CRYSTAL BAY SECTION ONE FINAL PLAT - Amended

PART S.W. & N.W. 1/4 SEC. 28-T36N-R14E STUEBEN COUNTY, INDIANA ZONING - R2 LAKE RESIDENTIAL

ROWLAND ASSOCIATES, INC. CONSULTING ENGINEERS - SURVEYORS P.O. BOX 138 120 1/2 E. MAUMEE ST. ANGOLA, IN 46703		SCALE: 1" = 100'	CHECKED: WJD
	PROJECT: CRYSTAL BAY SECTION ONE FINAL PLAT - AMENDED	DRAWING: AMENDED PLAT	FILE: 17-008	DATE: 1-20-17
		SHEET: P-1	OF: 5

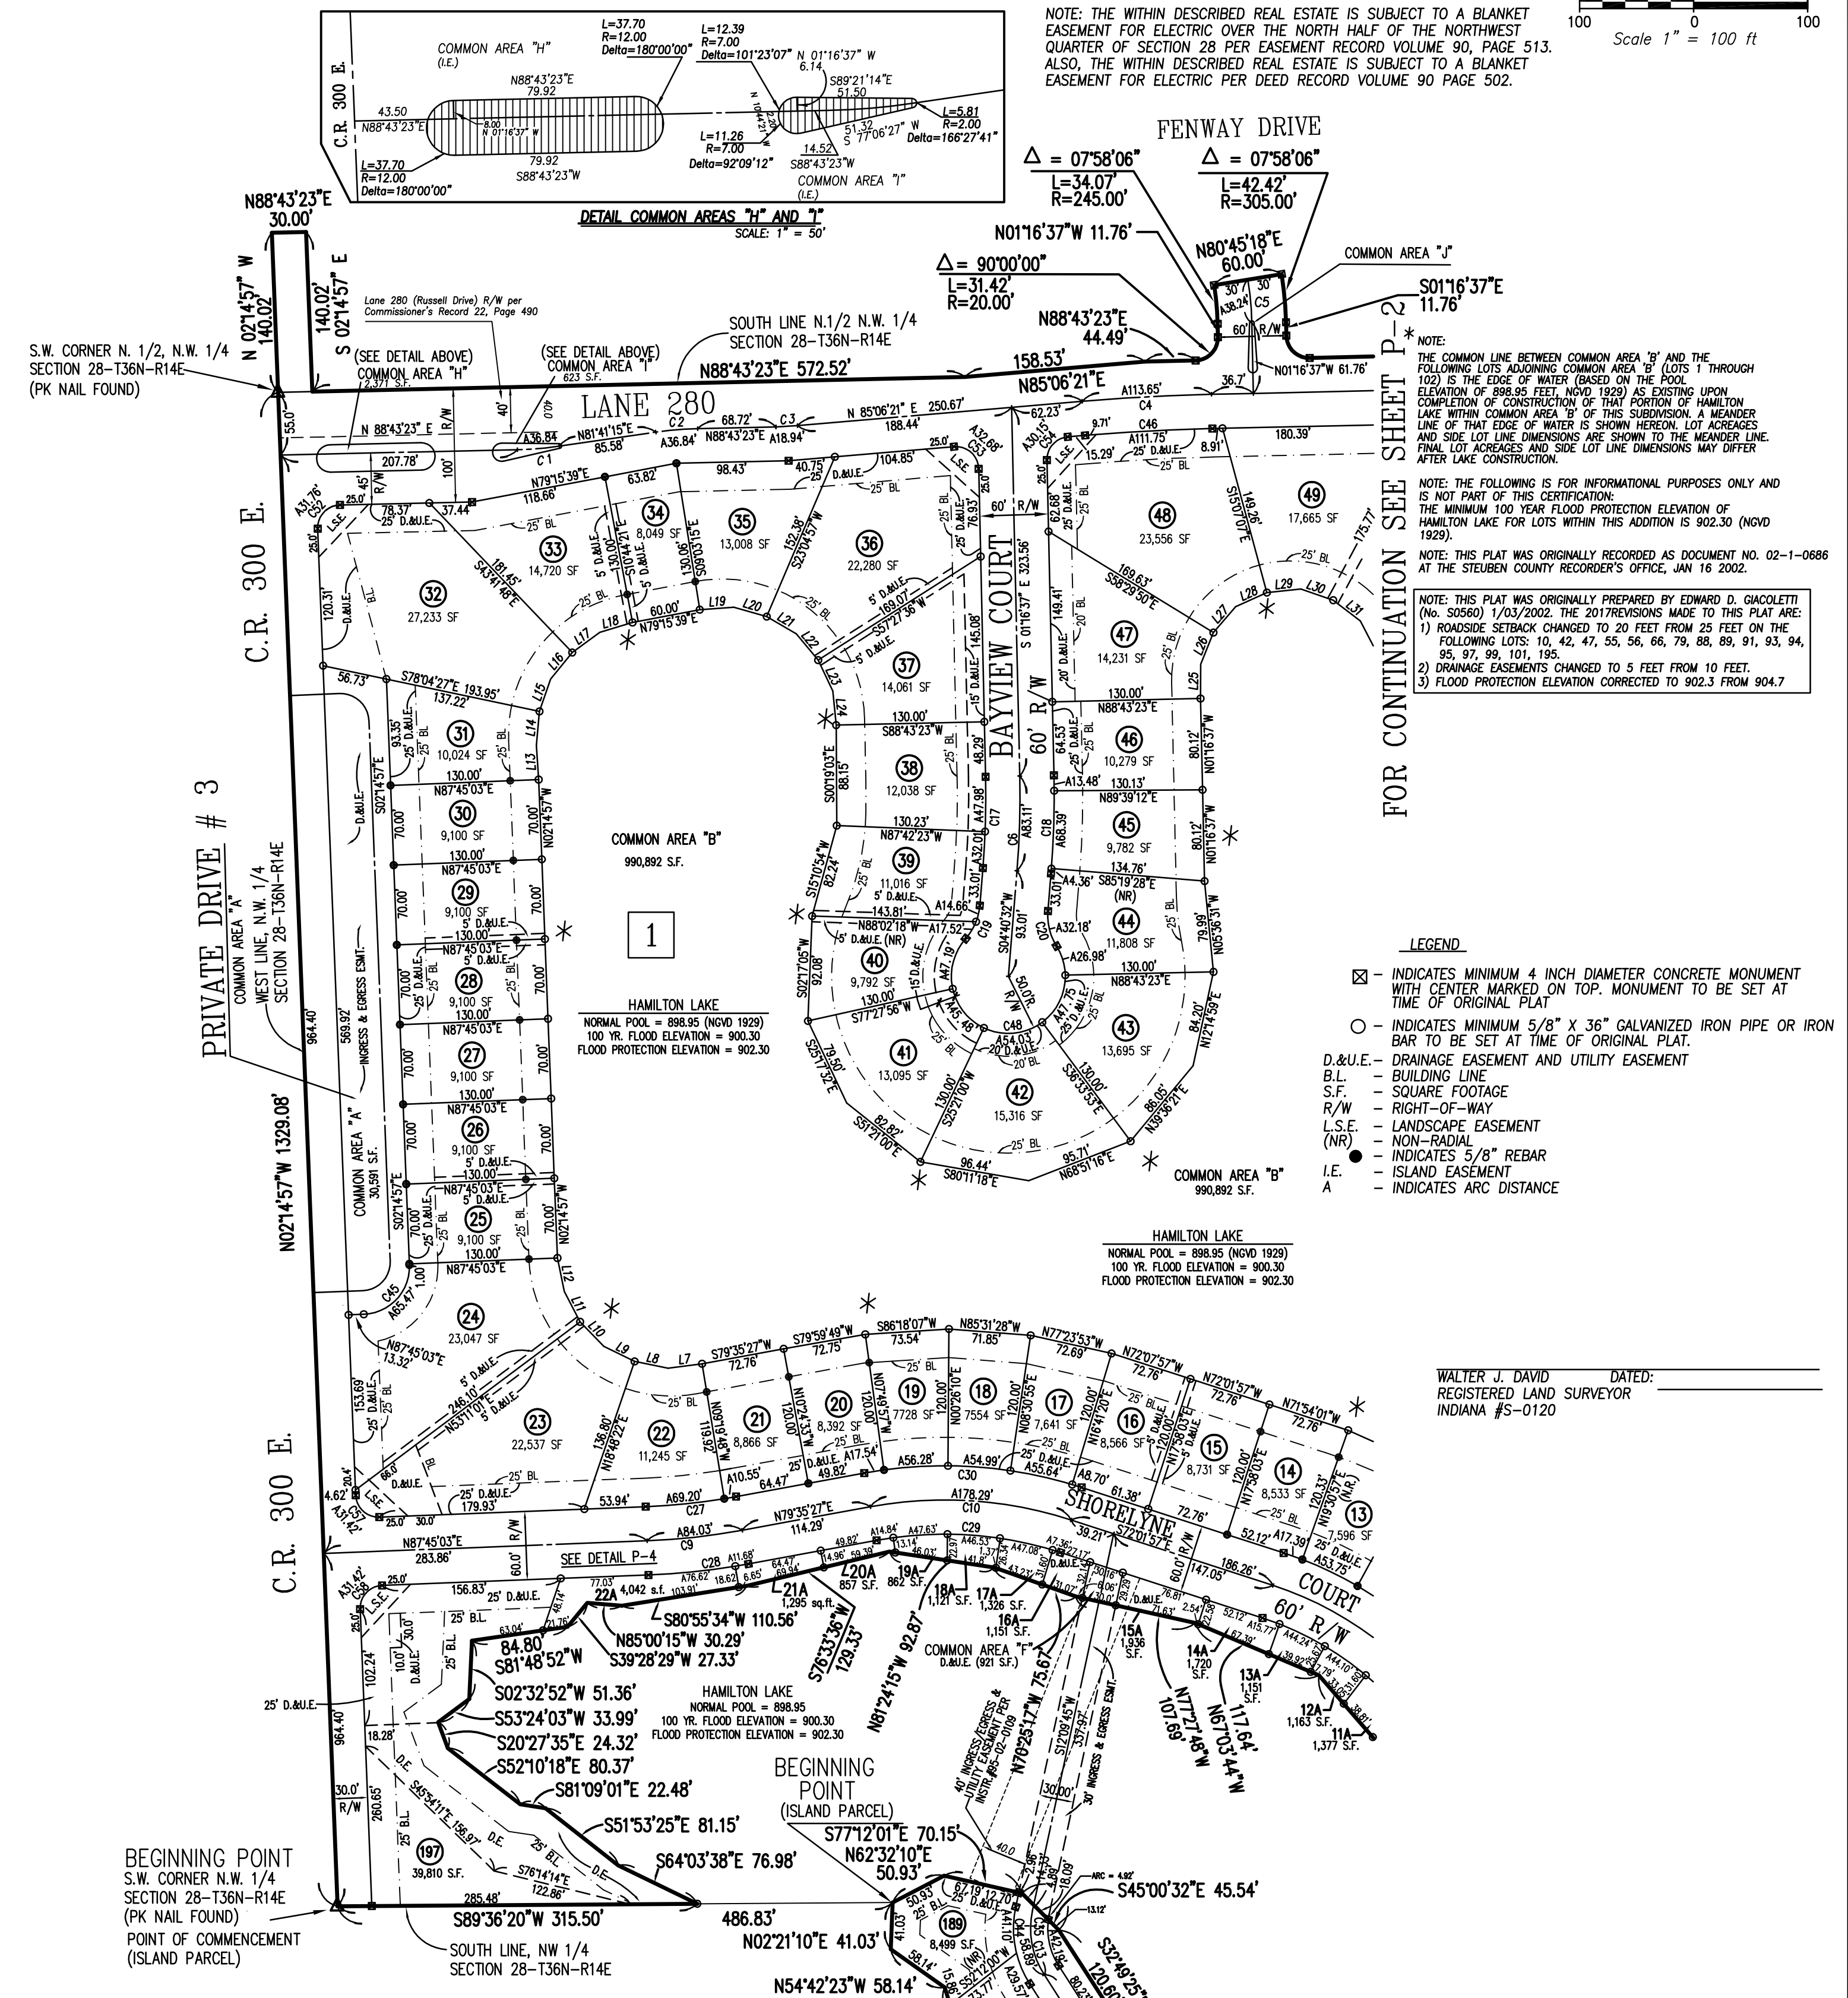
NOTE: THIS PLAT WAS ORIGINALLY PREPARED BY EDWARD D. GACOLETTI (No. S0560) 1/03/2002. THE 2017 REVISIONS MADE TO THIS PLAT ARE:
1) ROADSIDE SETBACK CHANGED TO 20 FEET FROM 25 FEET ON THE FOLLOWING LOTS: 10, 42, 47, 55, 56, 66, 79, 88, 89, 91, 93, 94, 95, 97, 99, 101, 195.
2) DRAINAGE EASEMENTS CHANGED TO 5 FEET FROM 10 FEET.
3) FLOOD PROTECTION ELEVATION CORRECTED TO 902.3 FROM 904.7

<p>ROWLAND ASSOCIATES, INC. CONSULTING ENGINEERS - SURVEYORS P.O. BOX 138 120 1/2 E. MAUMEE ST. ANGOLA, IN 46703</p>	SCALE: 1" = 100'	CHECKED: WJD
	FILE: 17-008	DATE: 1-20-17
	DRAWN: RJS	DESIGN: N/A
	PROJECT: CRYSTAL BAY SECTION ONE FINAL PLAT - AMENDED	DRAWING: AMENDED PLAT

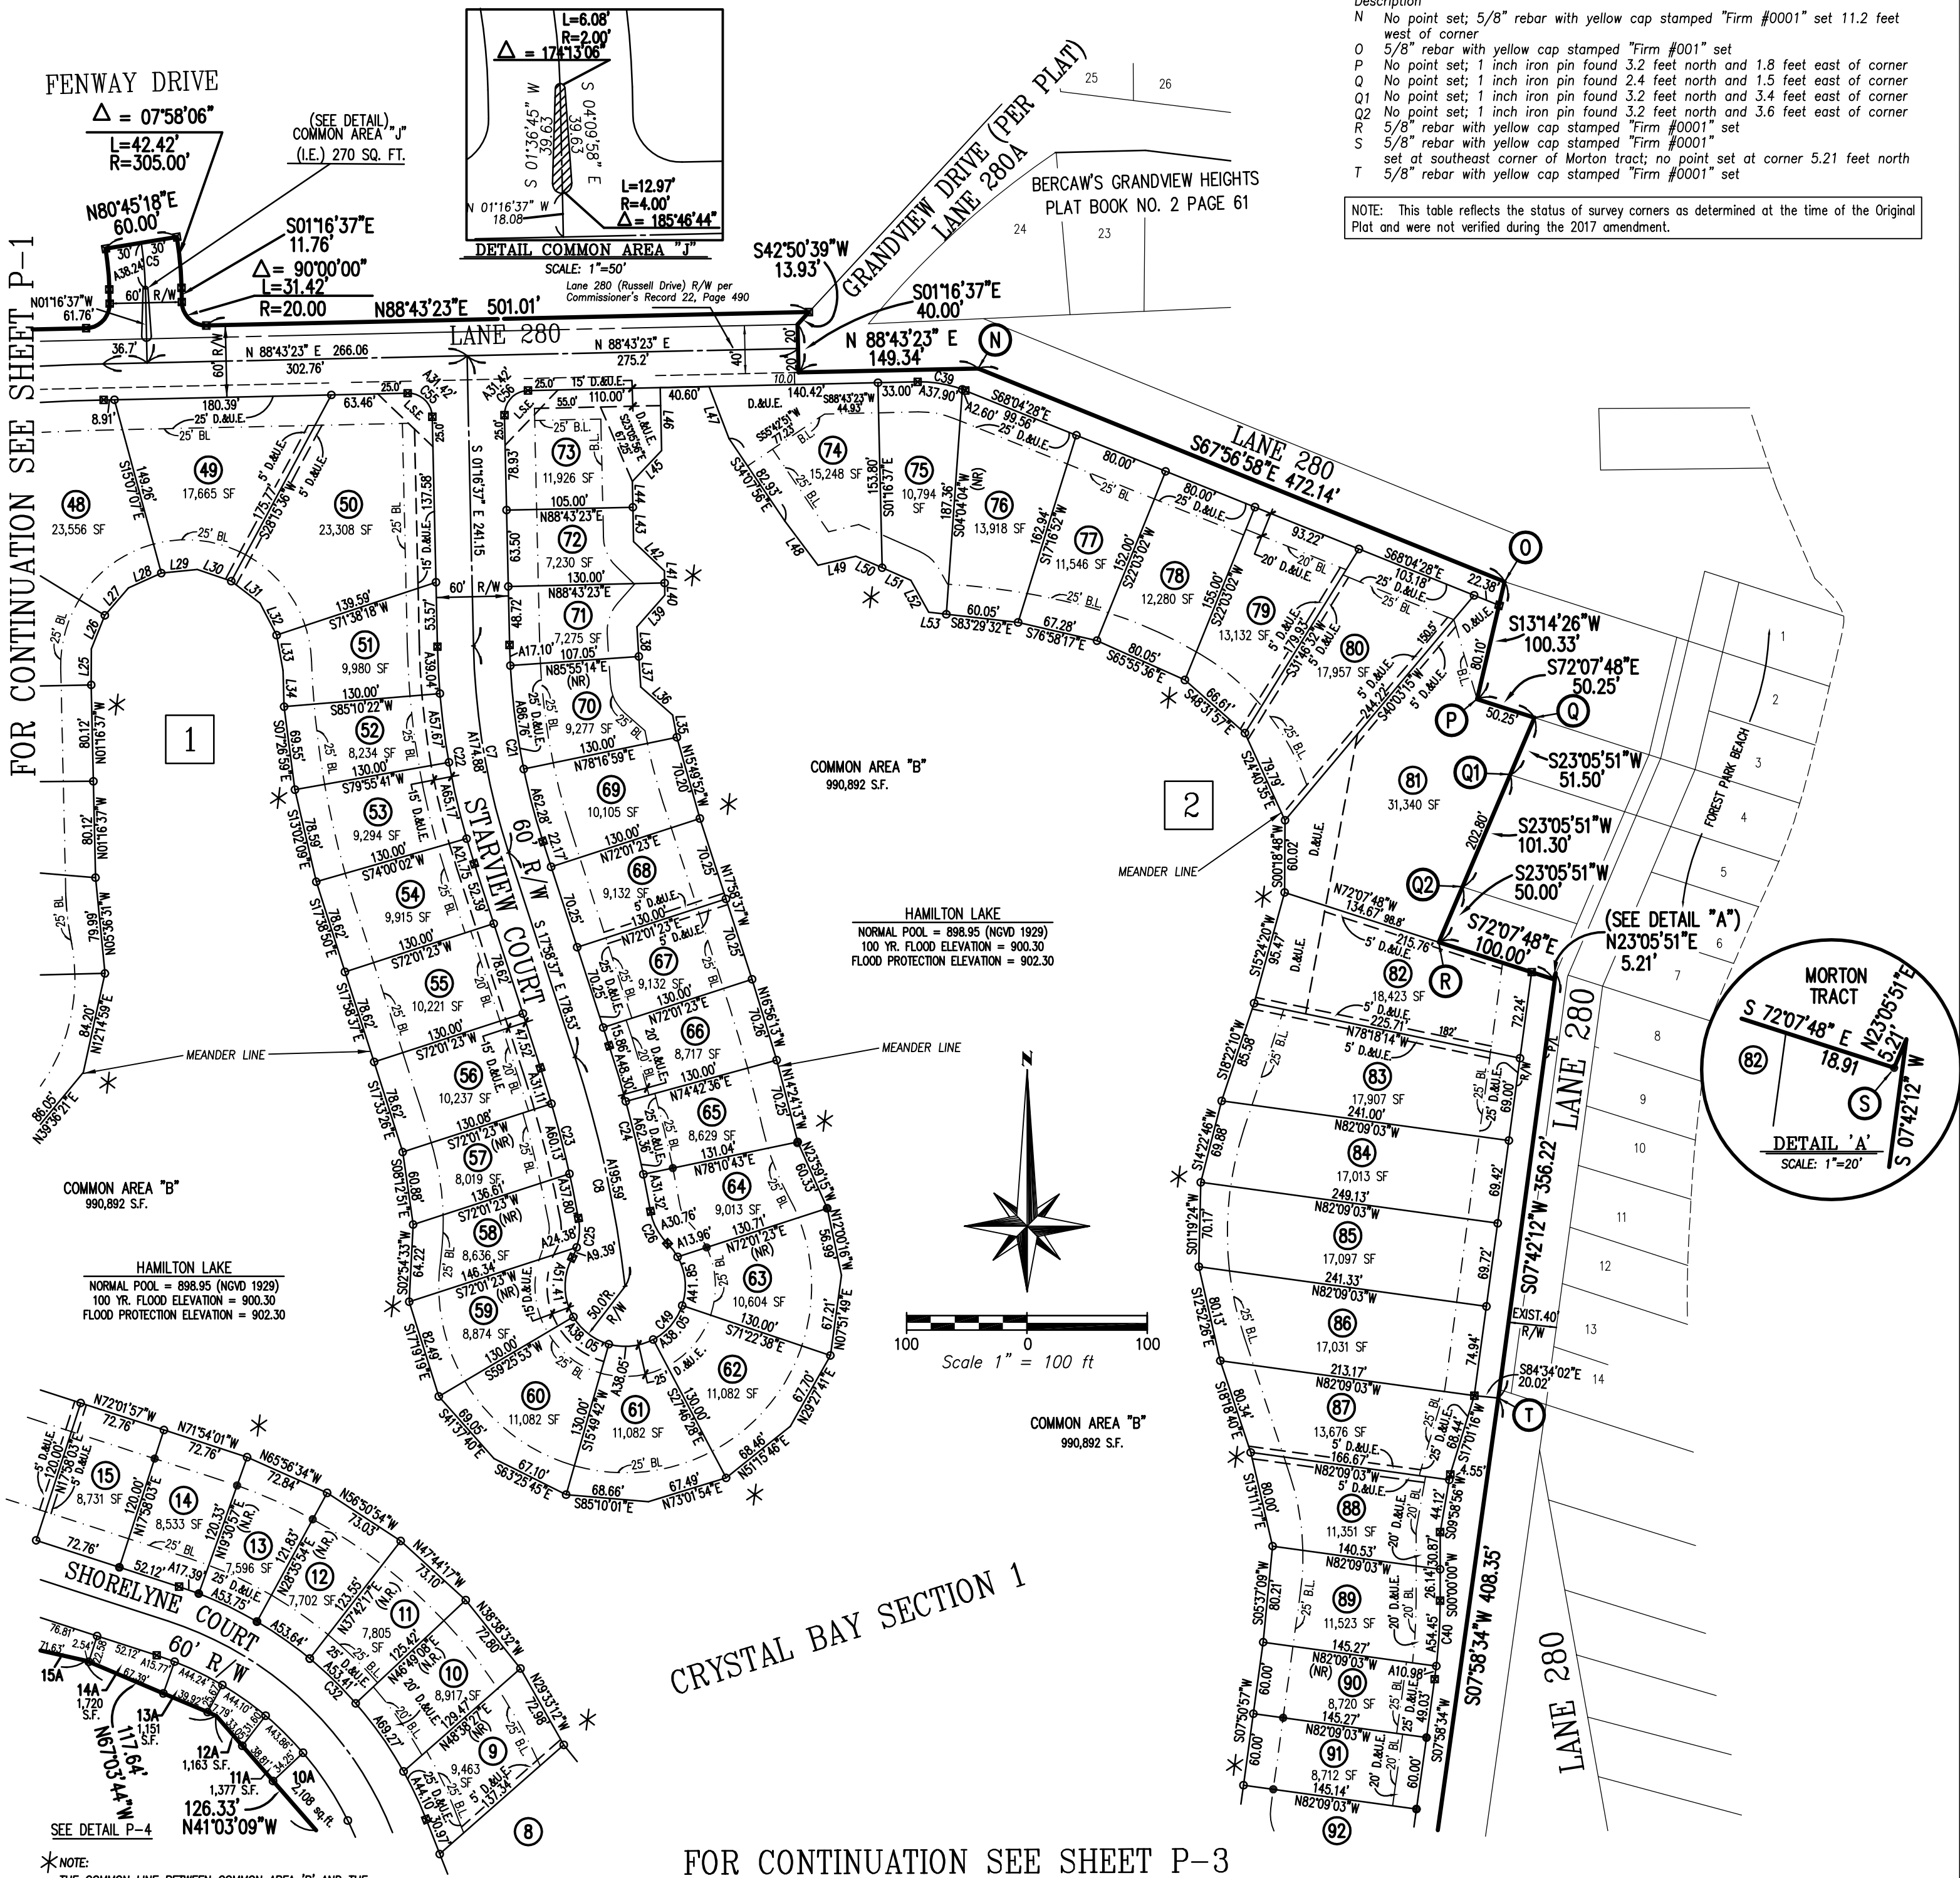
NOTE: THIS PLAT WAS ORIGINALLY PREPARED BY EDWARD D. GIACOLETTI (No. S0560) 1/03/2002. THE 2017 REVISIONS MADE TO THIS PLAT ARE:
 1) ROADSIDE SETBACK CHANGED TO 20 FEET FROM 25 FEET ON THE FOLLOWING LOTS: 10, 42, 47, 55, 56, 66, 79, 88, 89, 91, 93, 94, 95, 97, 99, 101, 195.
 2) DRAINAGE EASEMENTS CHANGED TO 5 FEET FROM 10 FEET.
 3) FLOOD PROTECTION ELEVATION CORRECTED TO 902.3 FROM 904.7

ROWLAND ASSOCIATES, INC. CONSULTING ENGINEERS - SURVEYORS P.O. BOX 138 120 1/2 E. MAUMEE ST. ANGOLA, IN 46703		SCALE: 1" = 100'	CHECKED: WJD
	PROJECT: CRYSTAL BAY SECTION ONE FINAL PLAT - AMENDED	DRAWING: AMENDED PLAT	FILE: 17-008	DATE: 1-20-17
SHEET: P-3	OF: 5	DRAWN: RJS	DESIGN: N/A

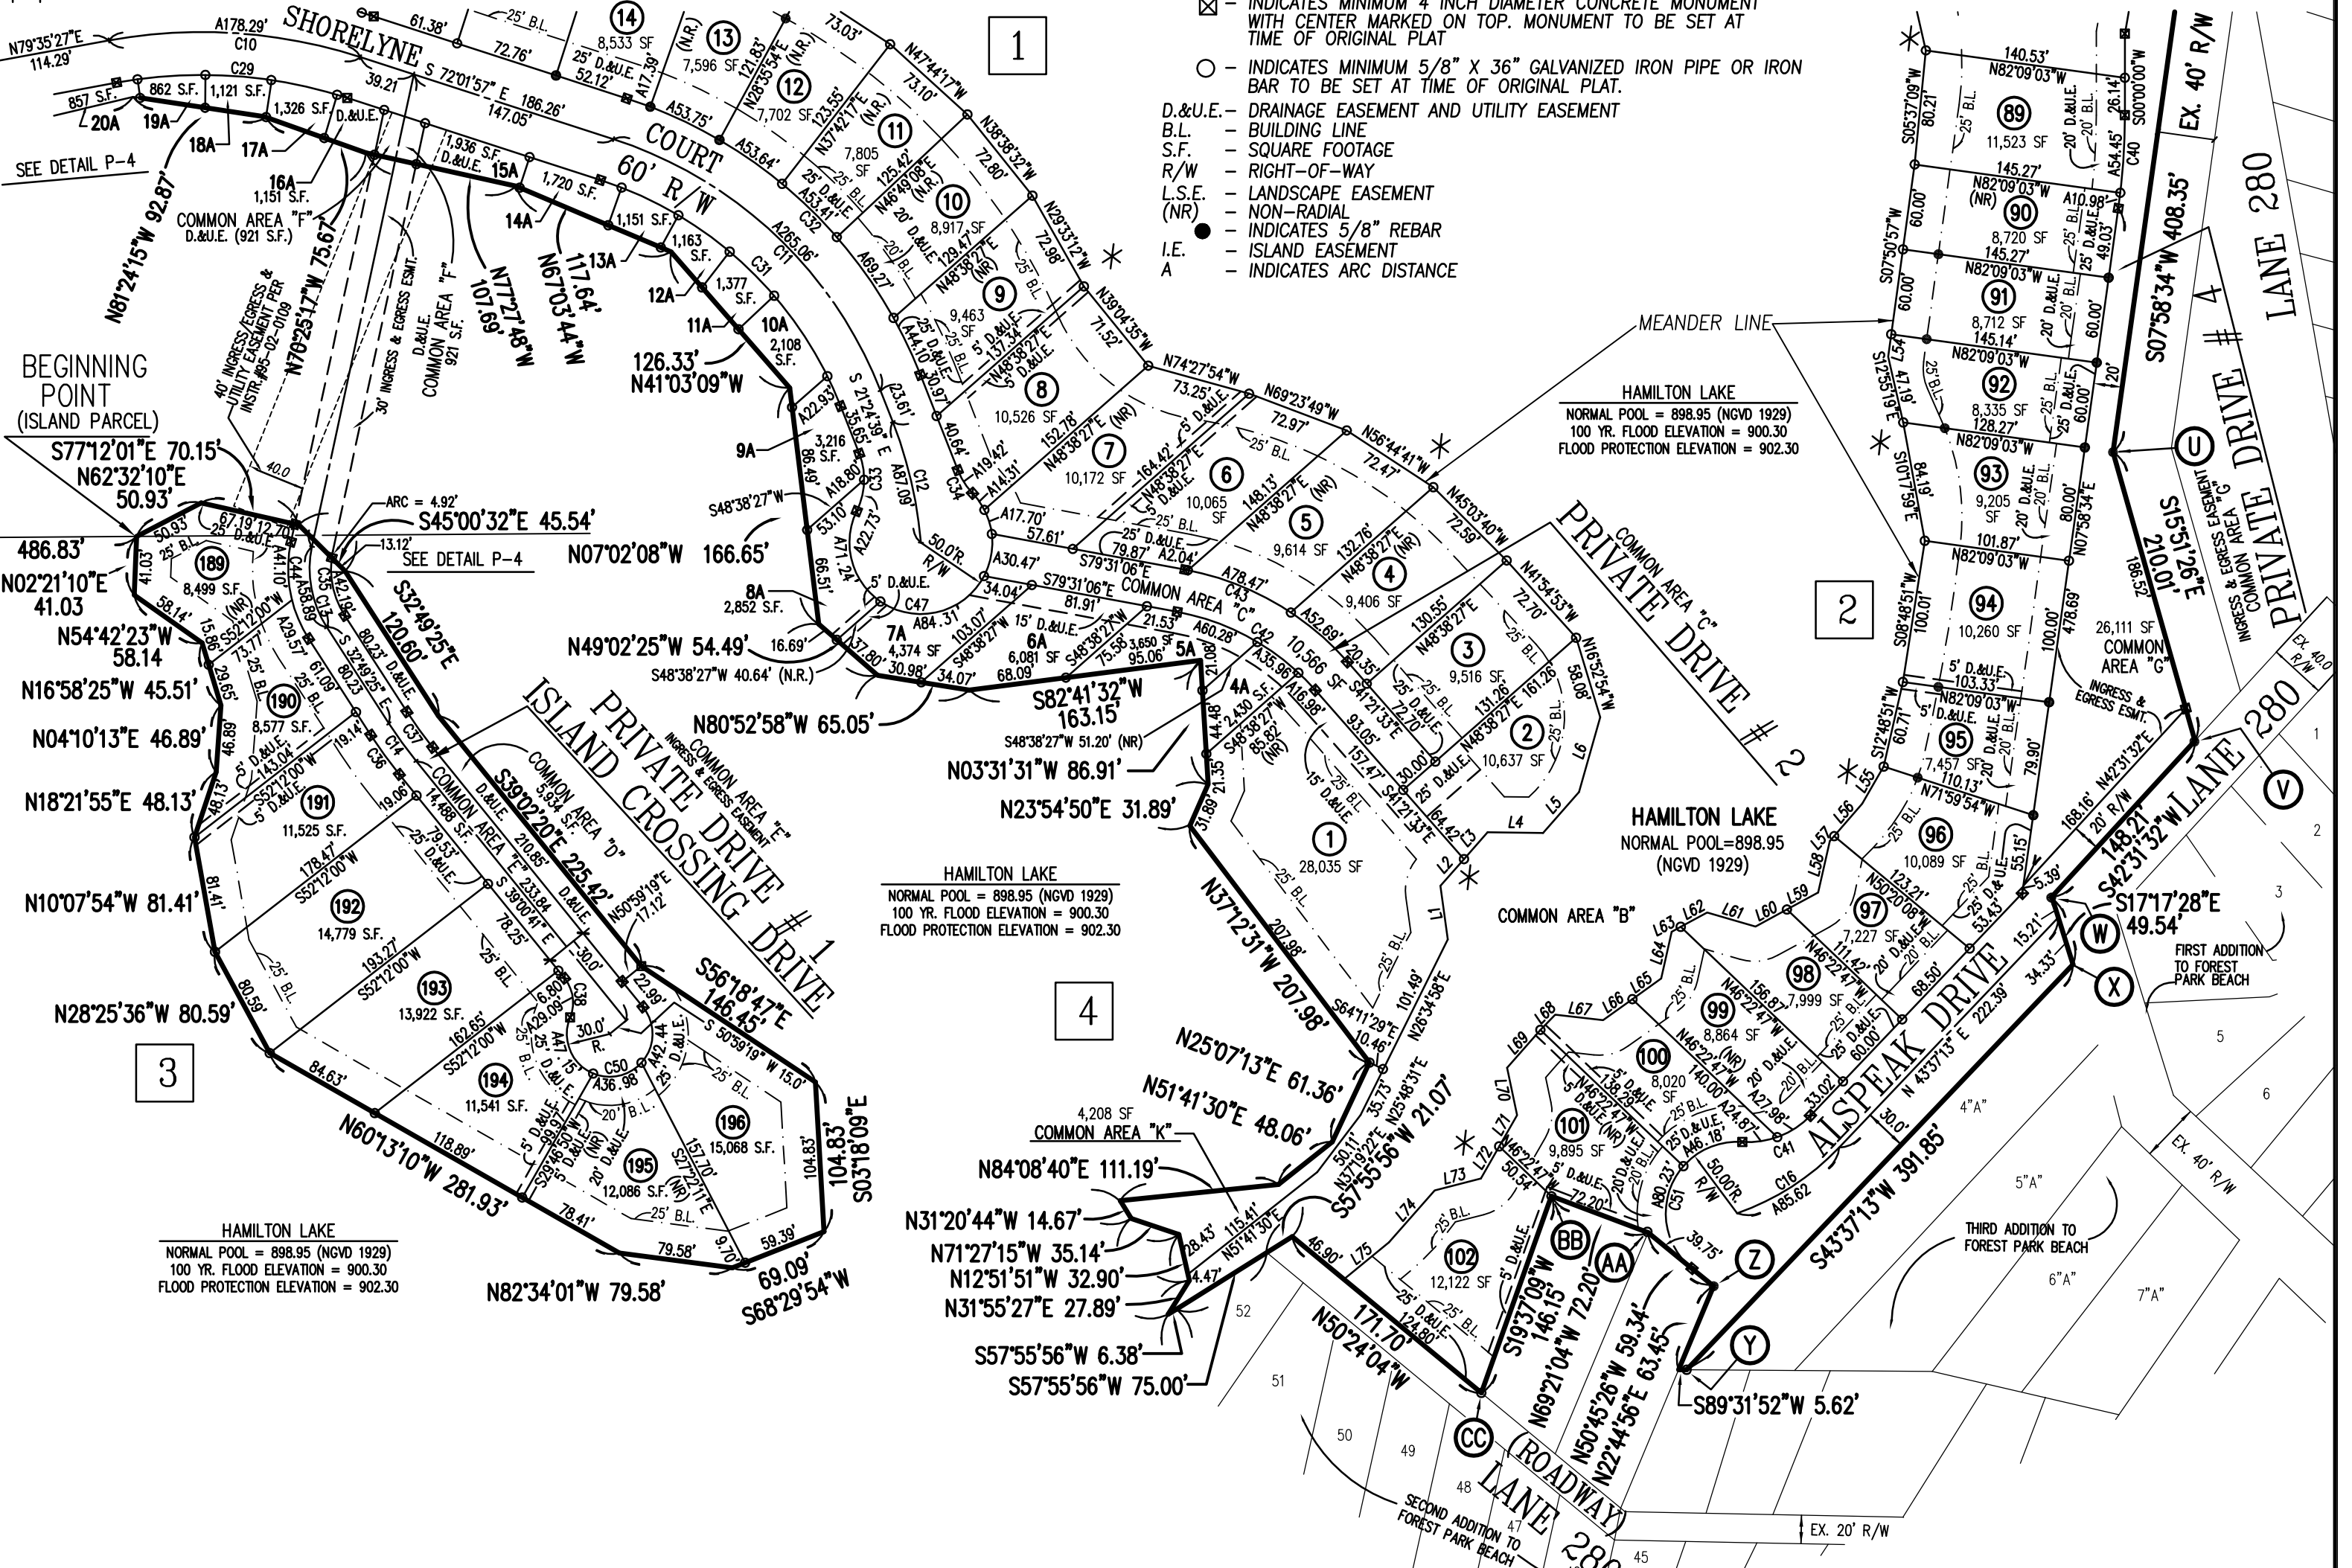
NOTE: THIS PLAT WAS ORIGINALLY PREPARED BY EDWARD D. GIACOLETTI (No. S0560) 1/03/2002. THE 2017 REVISIONS MADE TO THIS PLAT ARE:
1) ROADSIDE SETBACK CHANGED TO 20 FEET FROM 25 FEET ON THE FOLLOWING LOTS: 10, 42, 47, 55, 56, 66, 79, 88, 89, 91, 93, 94, 95, 97, 99, 101, 195.
2) DRAINAGE EASEMENTS CHANGED TO 5 FEET FROM 10 FEET.
3) FLOOD PROTECTION ELEVATION CORRECTED TO 902.3 FROM 904.7
